Dictation Products Service Bulletin

Model: CCP-200 RF/D

No. 4

Subject: No Audio

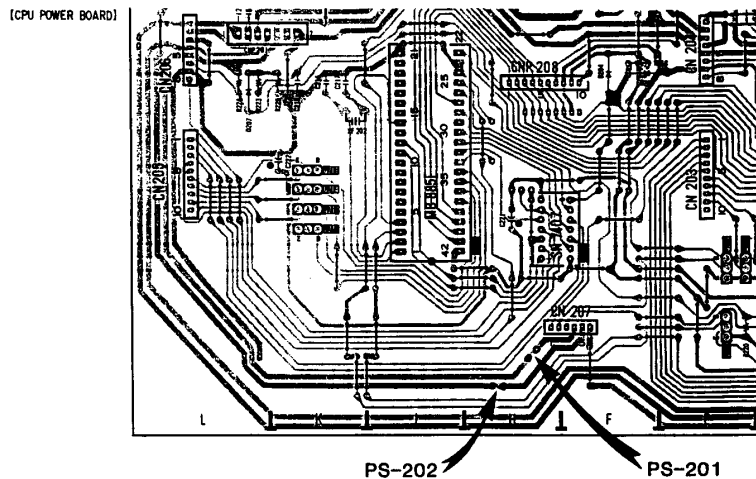
No audio on any of the channels.

Replace blown fuses on +15V and -15V power supply lines to the Audio Board.
The fuses are located at the H1 section of the CPU Power Board as PS-201 (+15V) and PS-202 (-15V).
